U. S. Nuclear Regulatory Commission Attention: Document Control Desk Washington, D.C. 20555 Serial No. 05-785B ESP/JDH Docket No. 52-008

DOMINION NUCLEAR NORTH ANNA, LLC NORTH ANNA EARLY SITE PERMIT APPLICATION RESPONSES TO DRAFT SAFETY EVALUATION REPORT OPEN ITEMS

On December 20, 2004, the NRC issued its Draft Safety Evaluation Report (DSER) for Dominion Nuclear North Anna, LLC's North Anna Early Site Permit application. The DSER contained open items for which the NRC requested a response by March 3, 2005.

Coordinate references based on the State NAD 83 South Zone coordinate system are provided in Figure 1 at the end of this response.

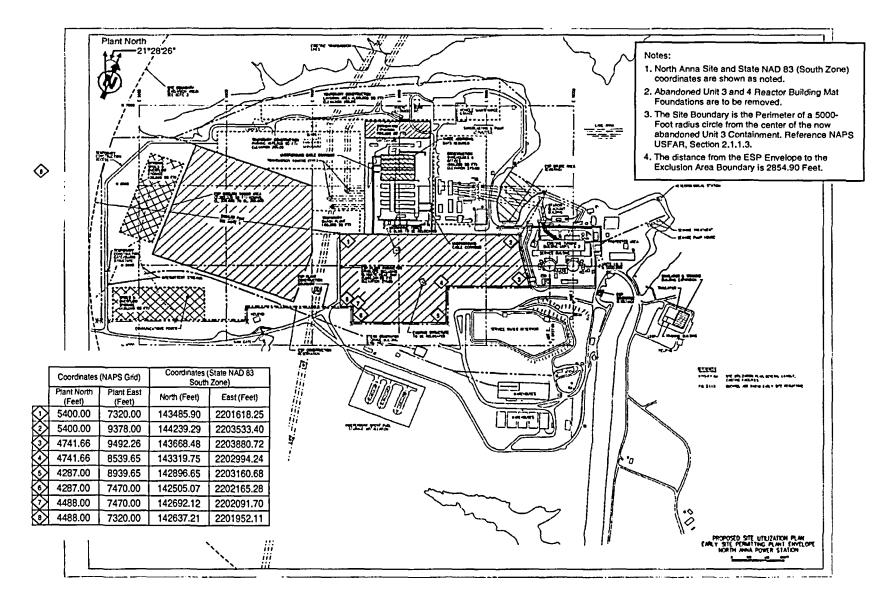
The applicant's response to RAI 2.4.1-1 included a figure that listed the coordinates of the corners of the ESP PPE (ESP site footprint). However, the applicant did not identify the coordinate system. The staff needs information regarding the coordinate reference system and the units of these coordinates to fully define the boundaries of the ESP site footprint. This is **Open Item 2.4-1**.

Figure 1 in the response to RAI 2.4.1-1 a) (Reference 1), provided the coordinates of the corners of the ESP PPE (ESP site footprint) based on the North Anna Plant Site coordinate reference system.

Both coordinate system units are "feet."

Figure 2.4-15 Groundwater Level Hydrographs

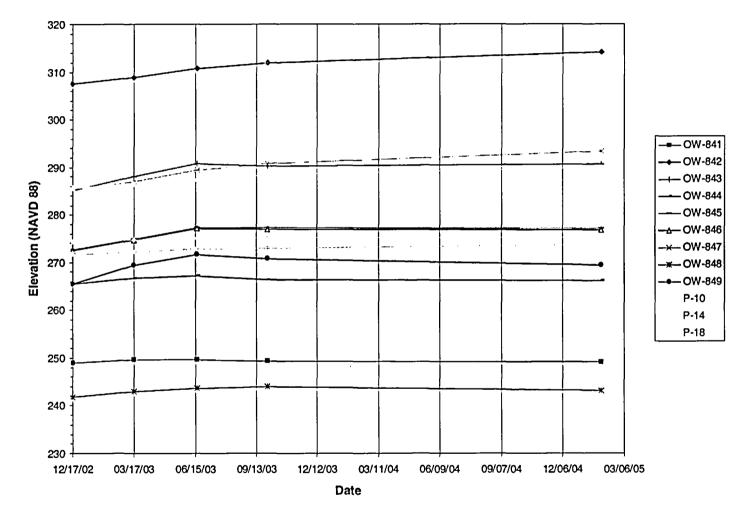
Observed increases in water levels in the new wells ranged from less than 0.3 m (1 ft) to more than 1 m (3 ft) over the period of December 17, 2002, through June 17, 2003. The applicant included previously existing wells monitored at the same time in the analysis. The observed variation in water levels in wells could be significant, but represented only a 6-month period. The staff evaluated additional information the applicant provided in response to RAI 2.4.12-1, but found that it needed additional data to determine whether the new ground water level measurements correlate with data from the long-term piezometers. Groundwater measurements should contain at least one full year of data to determine recent seasonal fluctuation in ground water levels at the ESP site. This is **Open Item 2.4-7**.

A supplementary round of groundwater level measurements were taken in the wells on February 1, 2005, about 1 year 4 months after the last quarterly groundwater level measurement and over 2 years after the drought had ended. Sufficient time has elapsed to allow the groundwater table to recover from the 2002 drought. SSAR Table 2.4-15 and SSAR Figure 2.4-15 have been updated to include the February 1, 2005 measurements (provided at the end of this response). In addition, Figures 1, 2, and 3 from the response to RAI 2.4.12-1 (Reference 1) have been updated with the additional groundwater level measurements (provided at the end of this response). The wells installed specifically for the ESP investigation generally show steady to slightly falling water levels between the current measurements and the previous measurements taken on September 29, 2003. Two wells (OW-842 and OW-847), however, show an increase in the groundwater level over this time period of 2.2 and 2.5 feet, respectively. Water levels in the previously existing site wells during this time period exhibit changes ranging from -0.2 to +1.7 ft with the majority of changes at 1 ft or less. Note that the water levels observed in the pre-existing piezometers P-10, P-14, and P-18 have been added to the revised SSAR Figure 2.4-15. For the period beginning December 17,

SSAR Table 2.4-15 and Figure 2.4-15 will be replaced with the revised versions shown on the next 3 pages.

GWL Contours 02-01-05

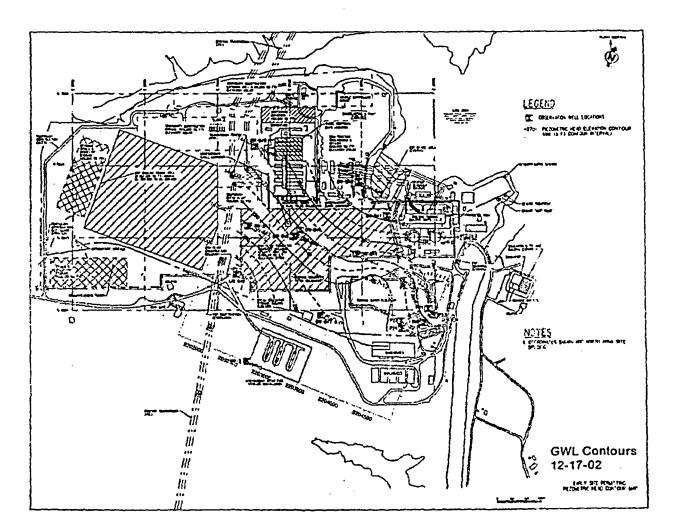
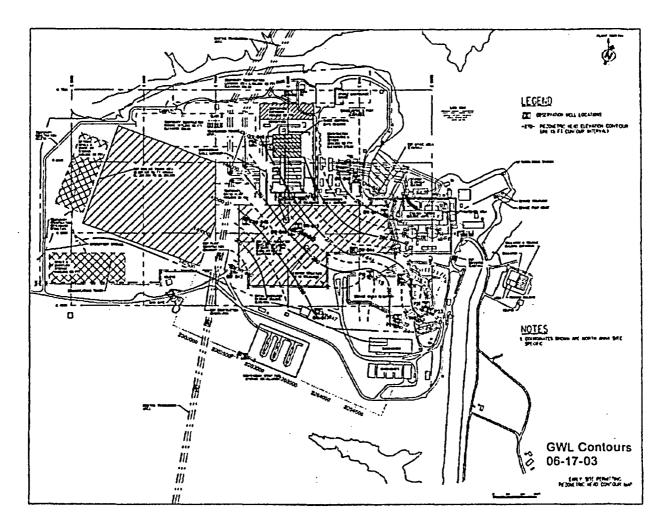
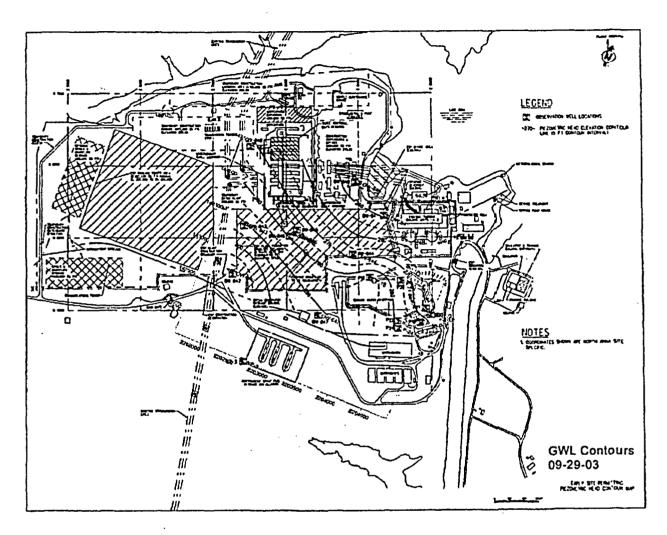
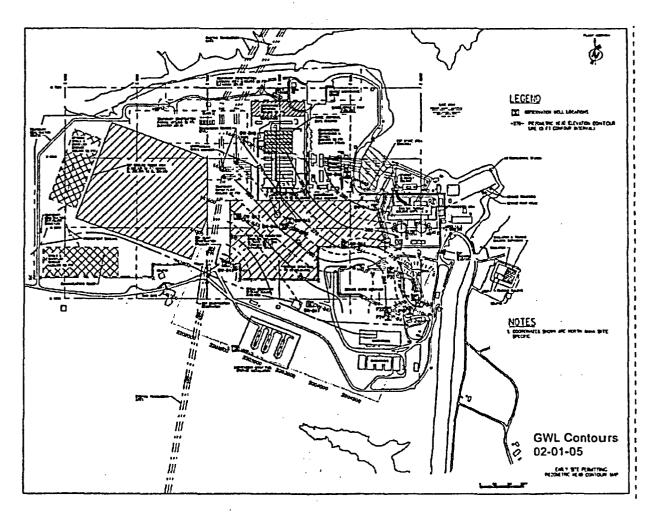
The applicant stated that the typical hydraulic gradient of ground water flow across the ESP site to Lake Anna and the WHTF is 0.03 m/m. The applicant based this estimate on only one piezometric head contour map constructed using ground water level observations from March 2003. The applicant stated that this hydraulic gradient is typical of the ESP site, despite seasonal and long-term variation in the ground water regime. However, the applicant should provide data to support this statement and to define the range of seasonal and long-term variation in hydraulic gradient from the ESP site into Lake Anna and the WHTF. This is **Open Item 2.4-10.** The staff intends to identify hydraulic gradient from the ESP site to Lake Anna and the WHTF as a site characteristic in any ESP that might be issued for this application.

Groundwater levels in the observations wells installed at the ESP site were monitored quarterly. A total of 4 rounds of quarterly measurements were obtained in the period beginning December 17, 2002 and ending September 29, 2003, and are provided in SSAR Table 2.4-15. Based on the groundwater levels recorded in the wells on March 17, 2003, a piezometric head contour map was prepared and included as SSAR Figure 2.4-16. Evaluation of the contour map indicated a horizontal hydraulic gradient of 0.028 ft/ft from the center of the ESP site footprint to Lake Anna.

A supplementary round of groundwater level measurements was performed on February 1, 2005 (see the response to DSER Open Item 2.4-7). The groundwater level elevations obtained from the last monitoring round, along with the 4 previous monitoring rounds, are provided on the updated version of SSAR Table 2.4-15 (at the end of the response to DSER Open Item 2.4-7).

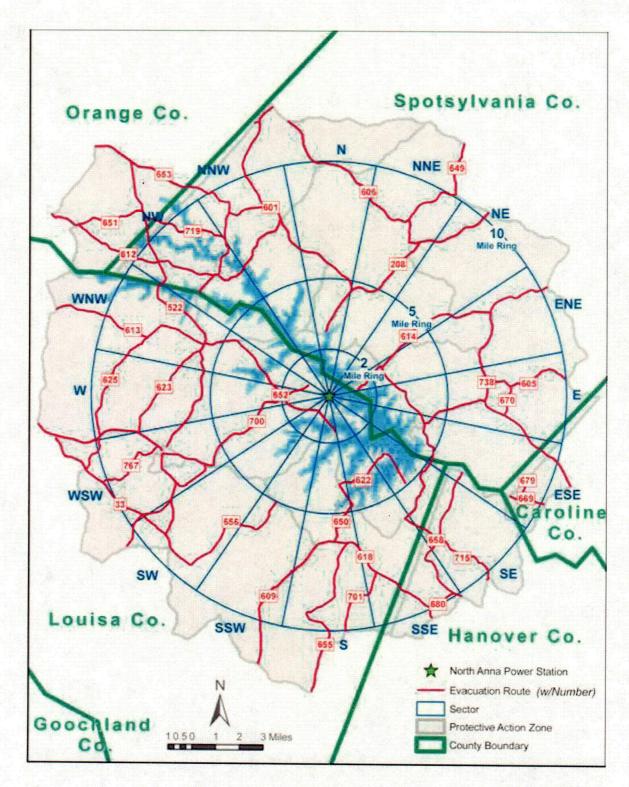
Please provide a figure (map) showing only those roads used as primary evacuation routes (e.g., Figure 3 of Appendix 4 to NUREG-0654/FEMA-REP-1), and also indicating the sector and quadrant boundaries.

Figure 1 (at end of this response) shows the primary evacuation routes, the sector and quadrant boundaries.
